Appeal by Hatton Solar Farm Limited under Section 78 of the Town and
Country Planning Act, 1990 in relation to

Appeal Ref: APP/D2510/W/25/3363157

Proof of Evidence on Landscape and Visual Matters

by Peter Radmall, MA, B.Phil, CMLI

Figure 3.1: Relationship to NL and AGLV

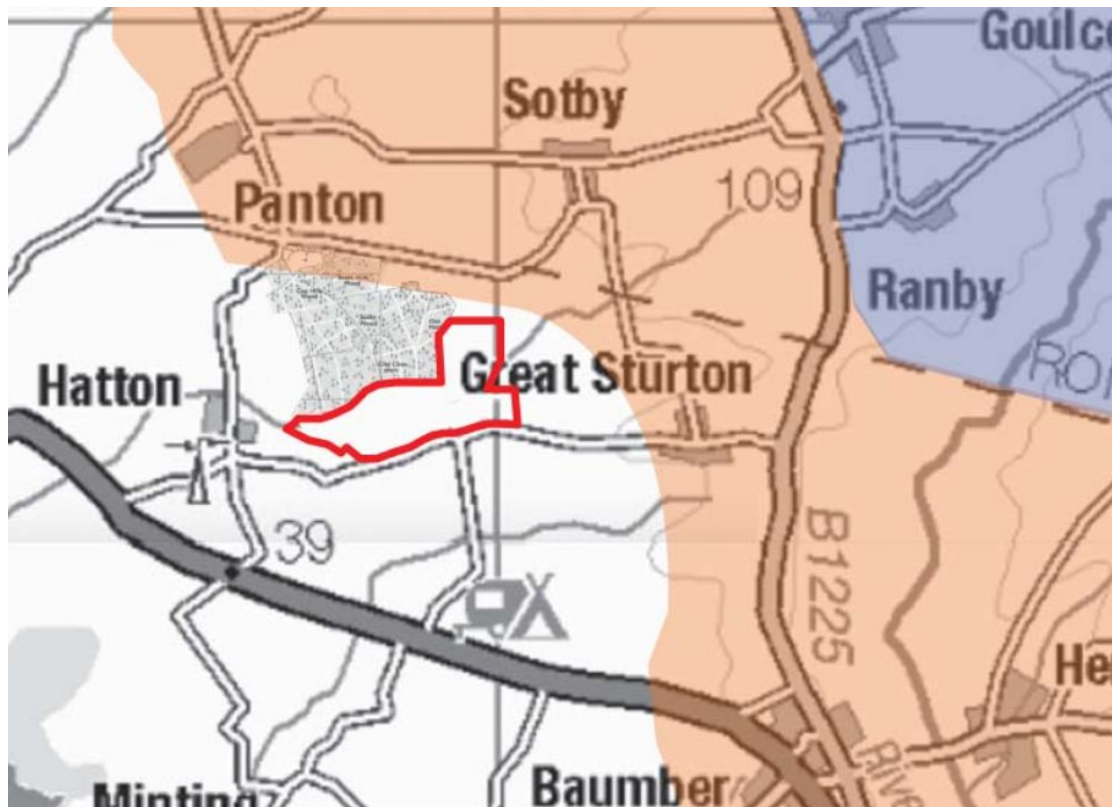
- 3.11 In addition to the (then) AONB, Figure 4 of the East Lindsey LCA shows an adjoining Area of Great Landscape Value (AGLV). An extract from this map is reproduced as **Figure 3.1** below, on which the AONB is shown in mauve and the AGLV in orange, and to which the appeal site has been added.

- 3.12 Because of the difference in scale between the OS base (to which the red line relates) and the smaller-scale map on which the AGLV is defined, care needs to be used in comparing their respective positions. Whilst the site appears not to fall within the AGLV, the proximity of the latter clearly indicates an increase in landscape value immediately to the north and east of the site, and within the potential visual influence of the development. Even allowing for my cautionary point above, the properties within Sotby that would experience close-range views of the solar farm (Greenacres, Moor Farm etc) are almost certainly located within the AGLV.

- 3.13 The LVIA makes limited reference to the AGLV, even though the AGLV is explicitly referred to in the LCA description of character area E1 as follows: *"The fabric of this agricultural landscape is based on a patchwork of fields and woodland interwoven with mature hedgerows with hedgerow trees and scattered rural settlements and farmsteads. Parts of the eastern edge of the area are designated as an Area of Great Landscape Value"* [My emphasis, LCA p44 [CD6.2].

Figure 6.1: Proposed Site Layout

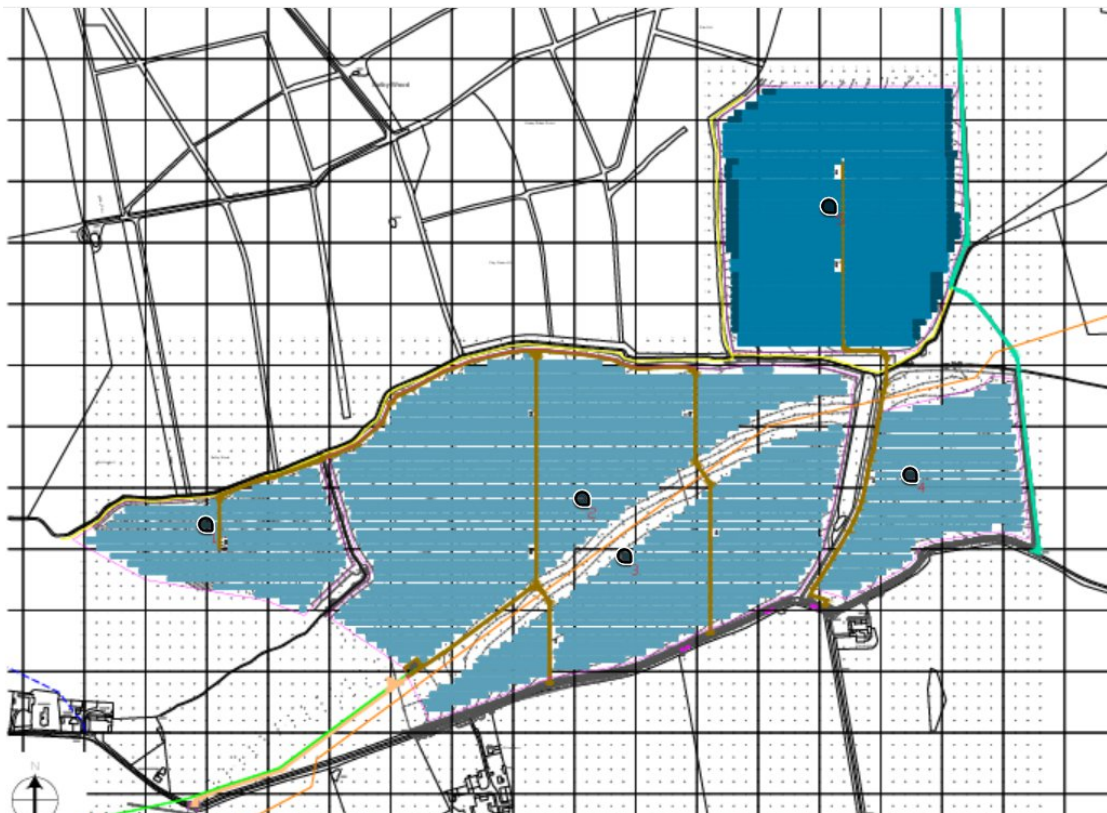
- 6.4 Panel Height: LVIA 2.1 states that the top edge of the panels would be no higher than 3m above existing ground level). By way of comparison, this is broadly equivalent to the height of a residential storey, and is well above normal eye-level (1.65m).

- 6.5 The height and density of the panels will be sufficient to obstruct ground-level views across the fields, depending on orientation and topography. Whilst some hedgerows in the area already appear to achieve this height, many do not (typically being @ 1.5m).

- 6.9 Once established, the combination of gapped up/new hedgerow/tree planting, especially along the northern/south-western boundaries of the site, would also contribute to the loss of openness and views. LVIA 3.5.1 states that new hedgerows would be managed at min 1.5/1.8m in height.

This is likely to be greater than many existing hedgerows, and since no maximum height is given could well be substantially more.

3.4 Viewpoint from West boundary, looking north-east and illustrating views from rear of properties (Old Barn)

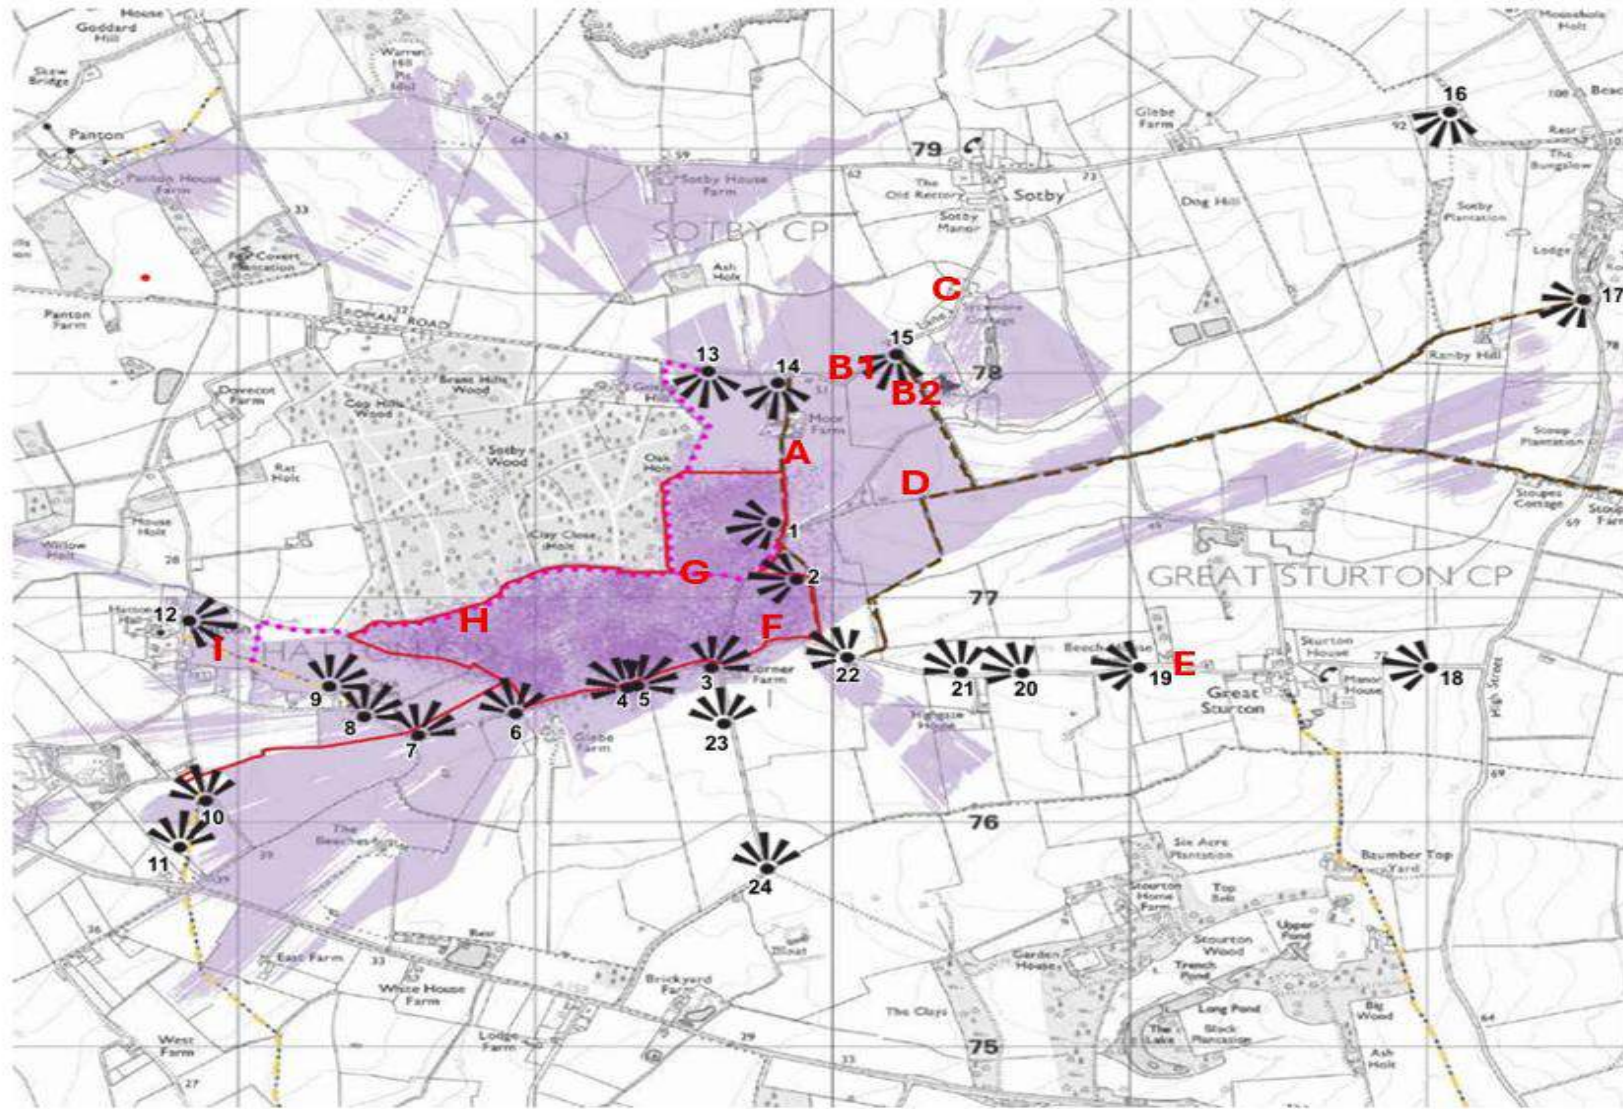
- a. In the absence of any 3D Visualisations being provided within the Appellant planning documents that clearly and appropriately demonstrate the visual impact of the solar panels and associated infrastructure on the current rural landscape, the Hatton Action Group (THAG) commissioned an architectural modelling company, Modunite, to carry out 3D visualisations of the proposal.
- b. Modunite specialises in producing high-quality CGI visualisations tailored for developers, architects, and builders seeking 3D representations of their projects and developments. Established in 2021, the company has cultivated a client base, serving over 600 clients across the UK.
- c. This work was commissioned in June (at the time of writing the R6 Statement of Case) and was carried out independently of the work carried out by Peter Radmall Associates .
